Rezoning Transportation Analysis

Petition Number: 2017-149

Date	Description
10-23-17	First Review

Figure 13a: South Boulevard Segment 1 Proposed Section (Long term)

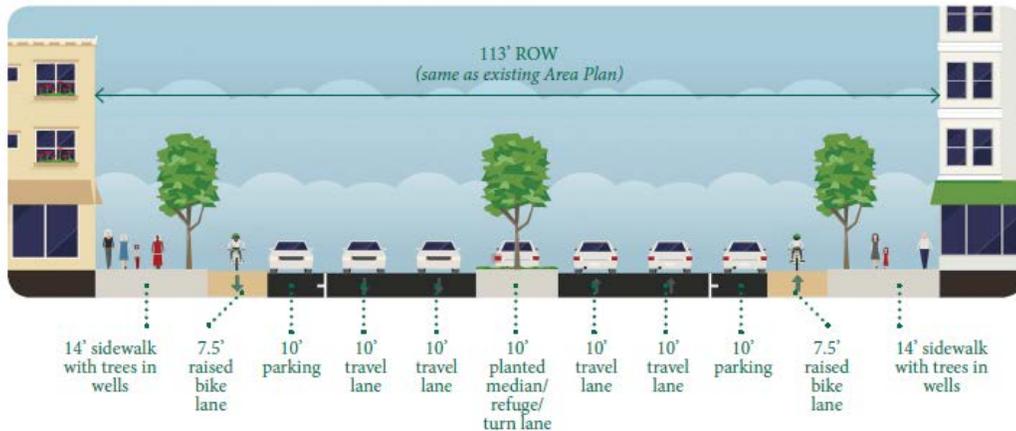
1. **Curbline** The proposed zoning district has a setback measured from back of the existing or proposed future curbline.
 - a. Kingston Av – the existing curbline is in the correct location per the area plan
 - b. South Blvd – 42.5' from centerline to accommodate the long-term cross section envisioned by the South Blvd-South Tryon Corridor Study. CDOT recognizes that the proposed reuse of an existing building overlaps with this curbline and will work with the petitioner to determine how to address this in the plan and notes for this project and future development when the existing building may be demolished.

5. CDOT recognizes that the future cross section will not be implemented across the entire site frontage. However, the petitioner should revise the site plan to show the future curbline as described in item 1 and future right of way across the South Blvd frontage as 59' from existing centerline to accommodate the long-term cross section envisioned by the South Blvd-South Tryon Corridor Study. CDOT and the petitioner will determine how the existing, near-term, and/or long-term curbline, streetscape, and right of way dedications will be accommodated for the current project across the outdoor space frontage and future development when the existing building may be demolished.
